**EXHIBIT "D"**  
**CAMPO DEL NORTE**  
**DESIGN VARIANCE**  
**REQUEST**  
**MAY 2018**

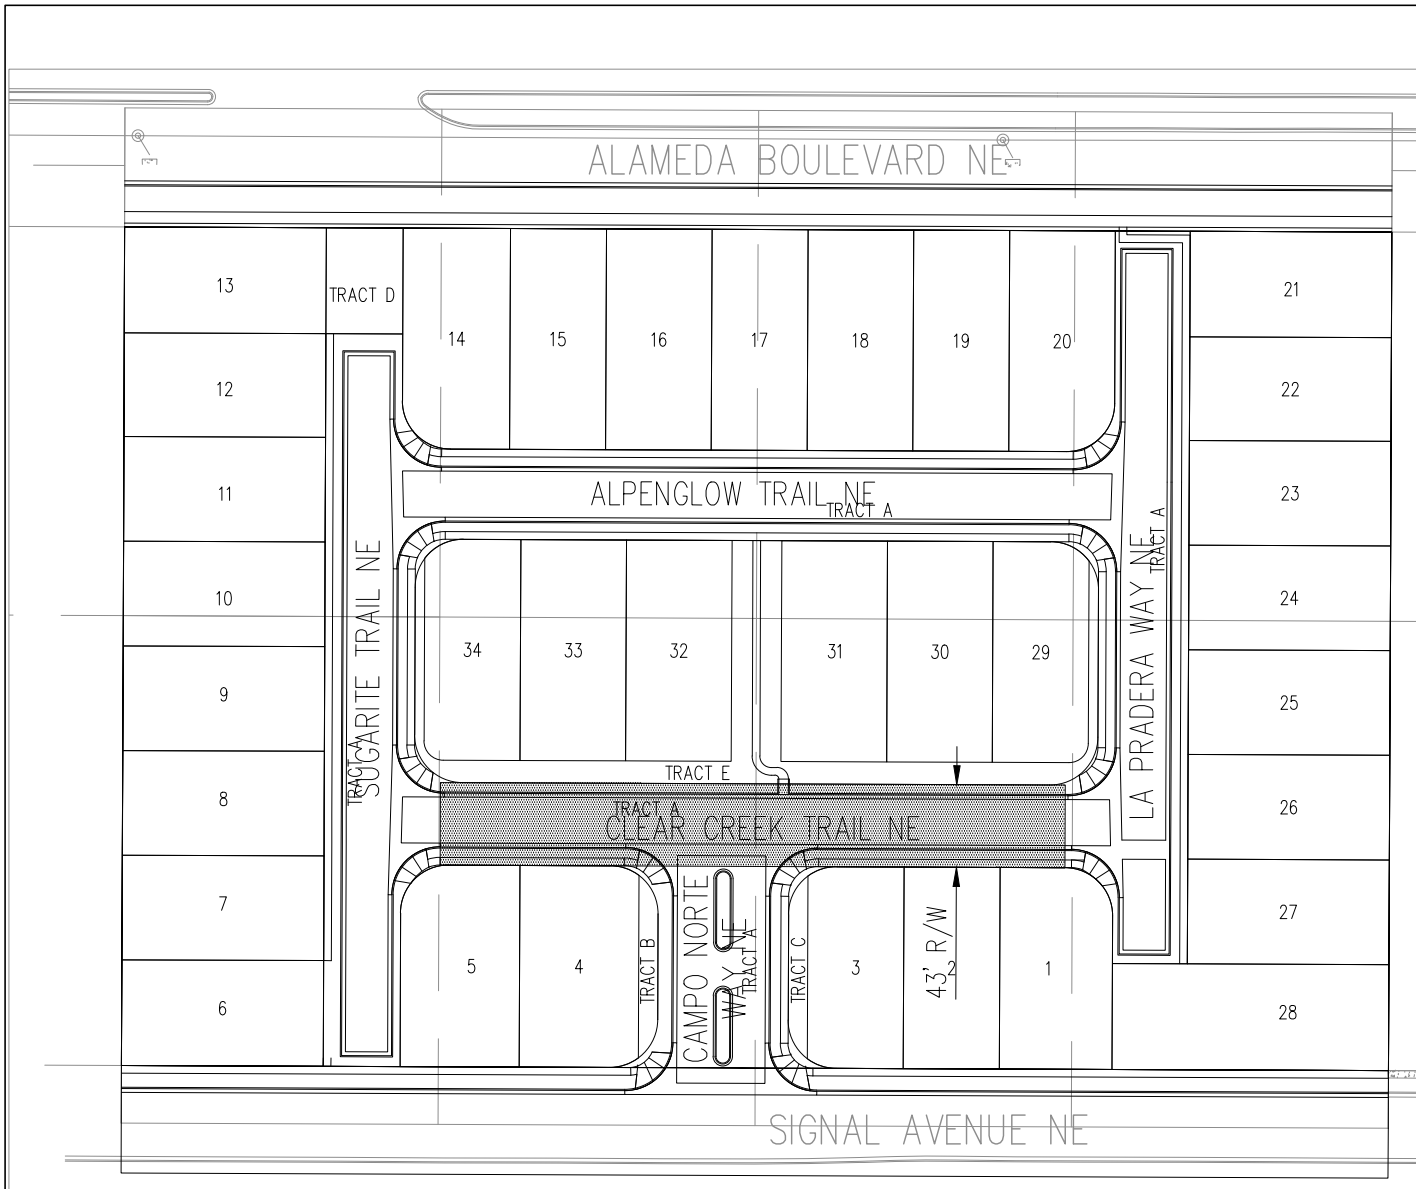
DESIGN VARIANCE REQUEST TO DPM CHAPTER 23, SECTION 2, PARAGRAPH B, TABLE 23.2.1.B STANDARD LOCAL RESIDENTIAL STREET DESIGN – PUBLIC RIGHT-OF-WAY AND PAVEMENT WIDTH STANDARDS TO REDUCE THE RIGHT-OF-WAY WIDTH FOR CLEAR CREEK TRAIL FROM 47' TO 43'. THE REDUCTION IN WIDTH IS JUSTIFIED DUE TO THE WAIVER OF SIDEWALK ON THE NORTH SIDE OF CLEAR CREEK TRAIL (SEE SIDEWALK EXHIBIT B), WHICH REDUCES THE NECESSARY RIGHT-OF-WAY WIDTH BY 4'. THE PAVEMENT WIDTH MEETS THE DPM STANDARD FOR A LOCAL ACCESS ROAD OF 28' FLOWLINE-TO-FLOWLINE.
